Topic: CIM 2040 Public Comments on Draft Plan

Background/Summary:

Communities in Motion 2040 Public Comments

Figure 3.5. CIM 2040 Vision

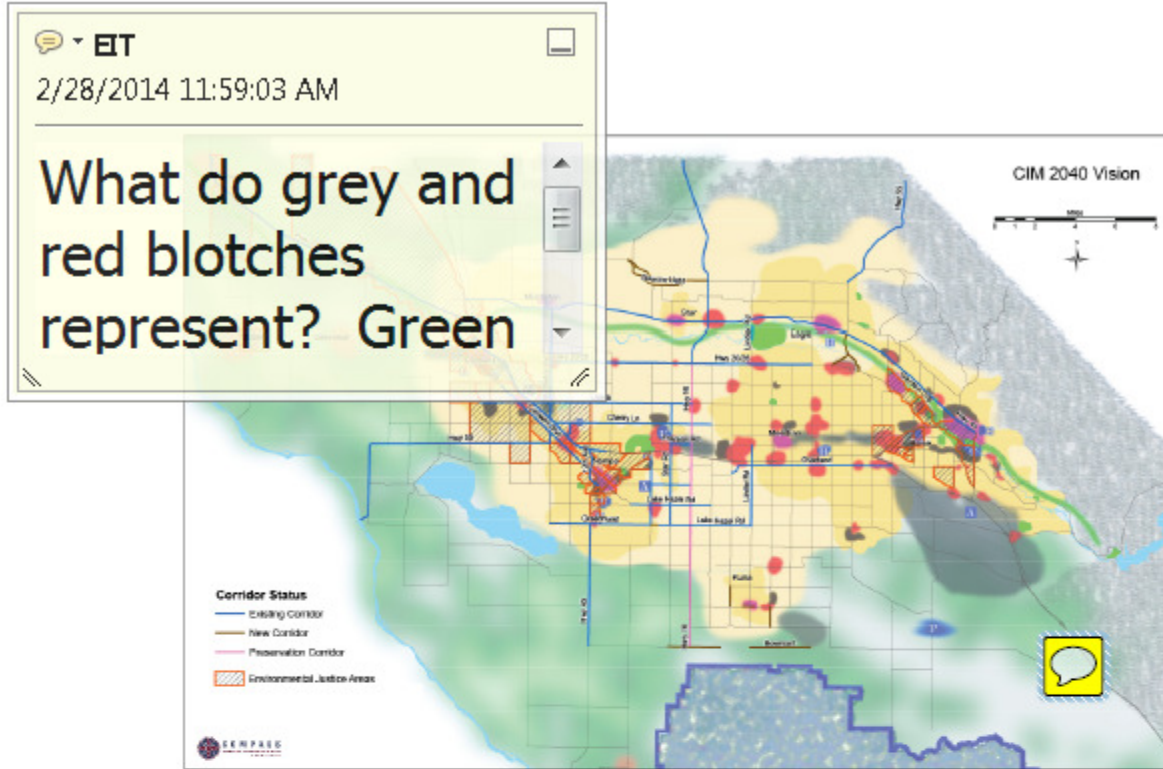
Need description of population area (2 county, UA's,

Figure 4.3. Future revenues, expenditures, and remaining funds available for system growth, Ada and Canyon Counties combined, assuming 4% inflation.

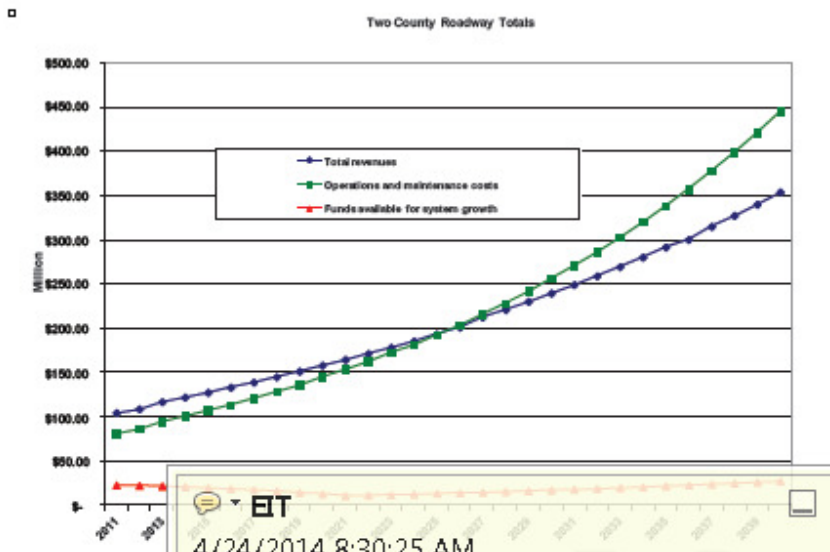
Line chart would better represent the fact that Canyon Co funding goes to zero
